Product Change Notification

PCN #:	AM20251112-1
Issue Date:	November 12 th , 2025
Products series affected:	AM30EW-LPZ series
Product list:	AM30EW-4805DLPZ
Effective Date:	All part numbers from the above product list shipping from Aimtec as of the issue date of this PCN.
Description of change:	All part numbers listed in the above product list from the AM30EW-LPZ series have their input under voltage lockout, on/off control idle current, transient recovery deviation, switching frequency, over current protection, weight, derating, typical application circuit Cin/Cout and recommended EMC circuit as per the details provided in the following ANNEX 1.
Reason for change:	This change has been implemented due to the EOL of critical raw materials.
Customer Impact:	Certain customers may be impacted by these changes in the specifications. Aimtec recommends reviewing the datasheet and testing samples as necessary.
Package Diagram:	N/A

ANNEX 1

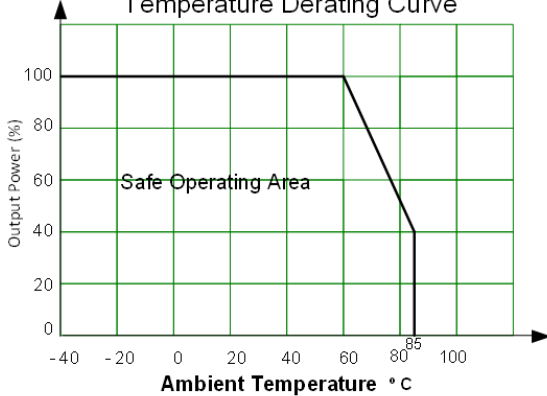
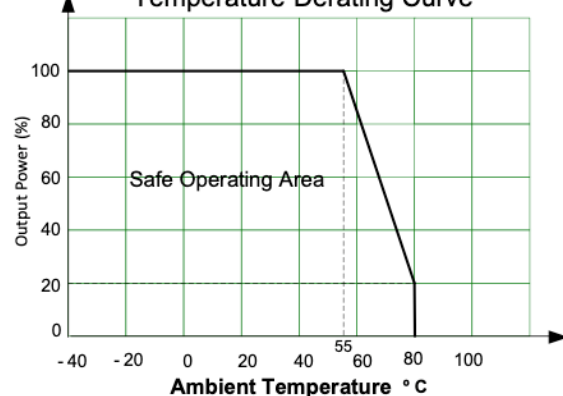
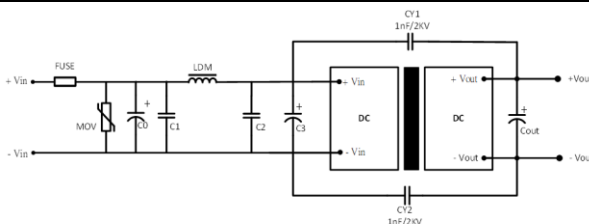
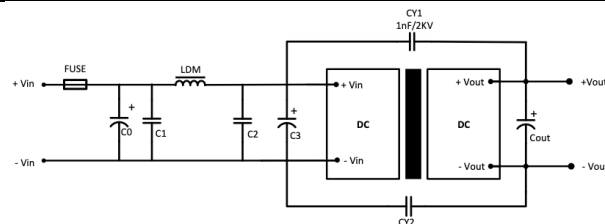
Parameter	Updated AM30EW-4805DLPZ	OLD AM30EW-4805DLPZ																											
Input under voltage lockout	12-16VDC typ.	12-15.5VDC typ.																											
On/off control idle current	2 - 5mA	5 - 8mA																											
Transient recovery deviation	25% load step change: ±3% typ. ±5% max.	25% load step change: ±5% typ. ±8% max.																											
Switching frequency	100% load: 300KHz typ.	100% load: 330KHz typ.																											
Over current protection	110% of Io typ. 240% of Io max.	110% of Io typ. 190% of Io max.																											
Weight	27g typ.	23g																											
Derating	AM30EW-4805DLPZ Temperature Derating Curve 	Single Output models Temperature Derating Curve 																											
Typical application circuit	Cin: 47μF/100V Cout: 220μF/16V	Cin: 100μF/100V Cout: 220μF/25V																											
EMC recommended circuit	<table><tr><th>Component</th><th>AM30EW-4805DLPZ</th></tr><tr><td>C0, C3</td><td>330μF, 100V</td></tr><tr><td>C1, C2</td><td>2.2μF, 100V</td></tr><tr><td>Cout</td><td>Refer to Cout in Typical Application Circuit</td></tr><tr><td>LDM</td><td>3.3μH</td></tr><tr><td>MOV</td><td>140101K</td></tr></table>	Component	AM30EW-4805DLPZ	C0, C3	330μF, 100V	C1, C2	2.2μF, 100V	Cout	Refer to Cout in Typical Application Circuit	LDM	3.3μH	MOV	140101K	<table><tr><th>Component</th><th>24Vin</th><th>48Vin</th></tr><tr><td>C0, C3</td><td>330μF, 50V</td><td>330μF, 100V</td></tr><tr><td>C1, C2</td><td>4.7μF, 50V</td><td>4.7μF, 100V</td></tr><tr><td>Cout</td><td>Refer to Cout in Typical Application Circuit</td><td>Refer to Cout in Typical Application Circuit</td></tr><tr><td>LDM</td><td>2.2μH, 4A</td><td>2.2μH, 2A</td></tr></table>	Component	24Vin	48Vin	C0, C3	330μF, 50V	330μF, 100V	C1, C2	4.7μF, 50V	4.7μF, 100V	Cout	Refer to Cout in Typical Application Circuit	Refer to Cout in Typical Application Circuit	LDM	2.2μH, 4A	2.2μH, 2A

Component	AM30EW-4805DLPZ																												
C0, C3	330μF, 100V																												
C1, C2	2.2μF, 100V																												
Cout	Refer to Cout in Typical Application Circuit																												
LDM	3.3μH																												
MOV	140101K																												
Component	24Vin	48Vin																											
C0, C3	330μF, 50V	330μF, 100V																											
C1, C2	4.7μF, 50V	4.7μF, 100V																											
Cout	Refer to Cout in Typical Application Circuit	Refer to Cout in Typical Application Circuit																											
LDM	2.2μH, 4A	2.2μH, 2A
